NEW ORLEANS TO VENICE, LOUISIANA

REACH B-1 -TROPICAL BEND TO FORT JACKSON

EMPIRE FLOODGATE

PERIODIC INSPECTION REPORT NO. 6

PHOTO 4 - Uncapped timber piles

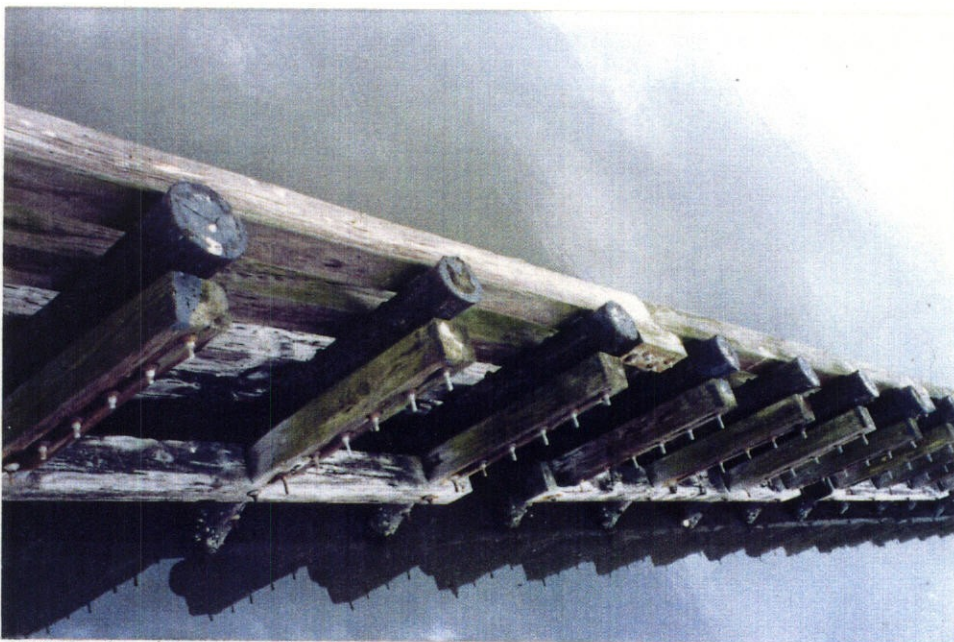
e. Approach Channels. The general condition of the timber guide walls, fenders and dolphins were excellent. Almost all the timber piles and vertical wales need to be capped. (See Photo 4).

(5) Timber piles and vertical wales will be capped.

PHOTO 5 - Typical corrosion on sections of hoist and counterweight chains in the splash zone

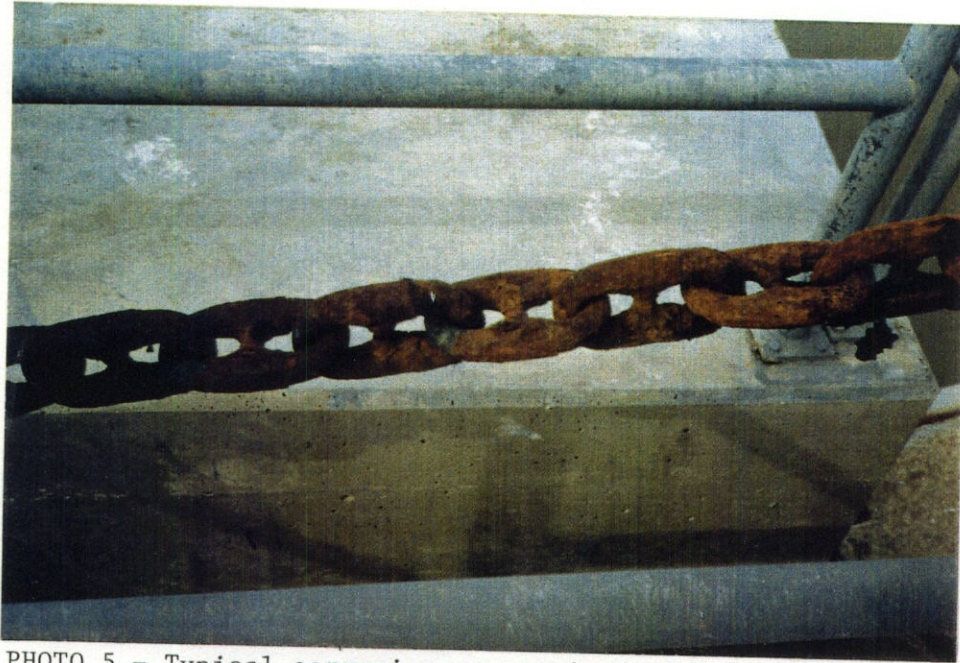
1. Hoist Chains and Counterweight Chains. Several links in the splash zone were severely corroded. (See photo 5). In the past year some links in the hoist chain have broken while lifting the gate. Failure of these links was due to corrosion. The sections of hoist chains and counterweight chains in the splash zone should be replaced prior to dewatering the structure.

(6) The sections of corroded hoist chains and counterweight chains, in the splash zone, will be replaced.

JET SUCTION DREDGE

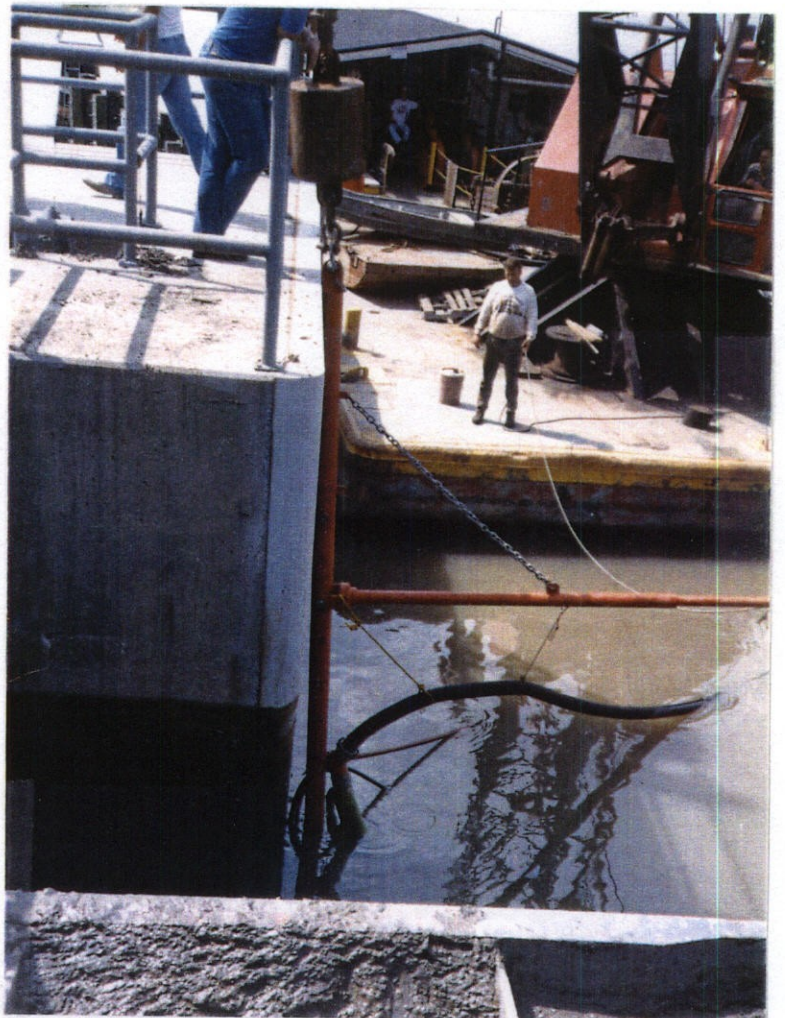
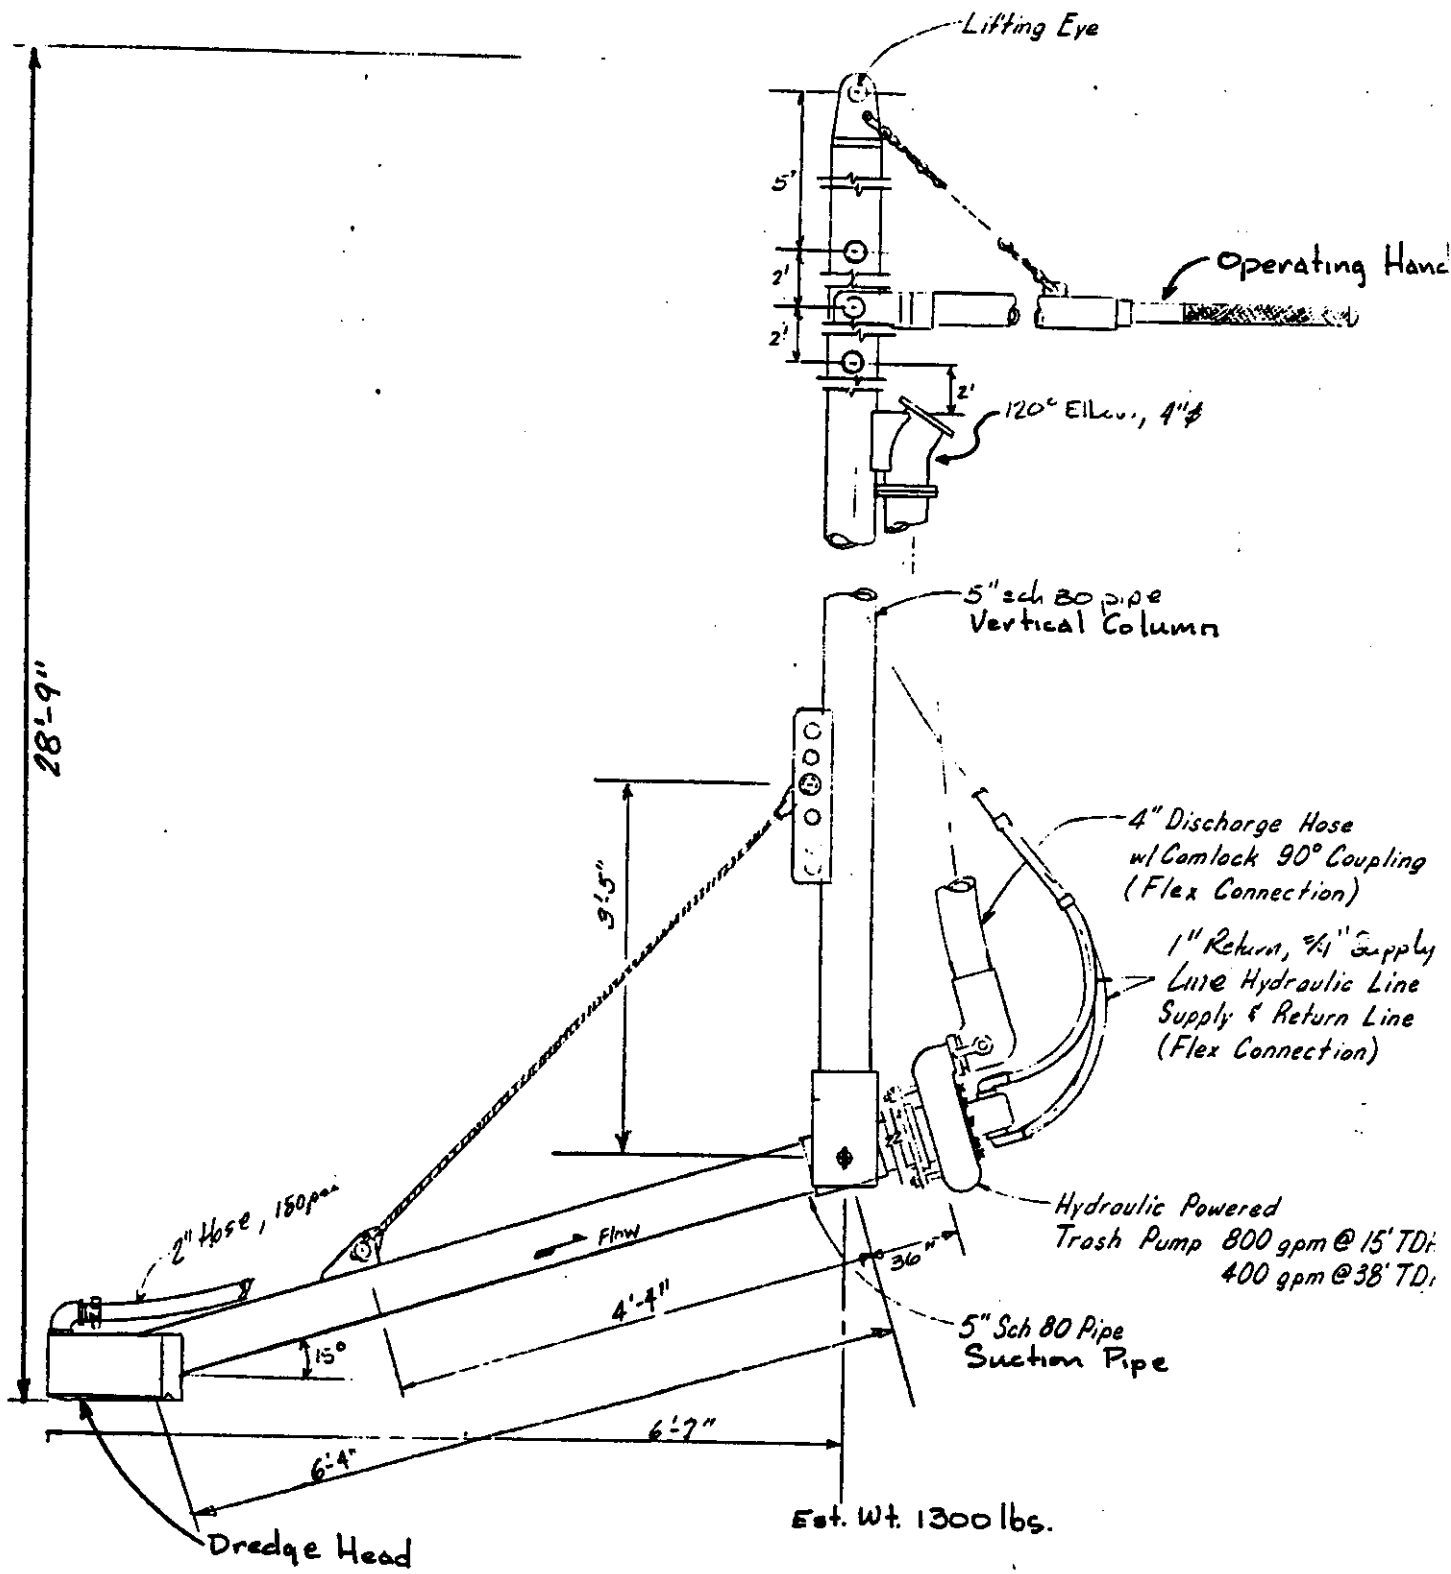
The New Orleans District designed and built a small jet dredge based on a letter request from Plaquemines Parish for a method of cleaning the silt from underneath Empire Floodgate. The jet dredge was designed for cleaning the side concrete recesses and areas around the hinges not easily cleaned by conventional dredge methods. Major silt removal is accomplished by either a bucket dredge or a much larger jet dredge.
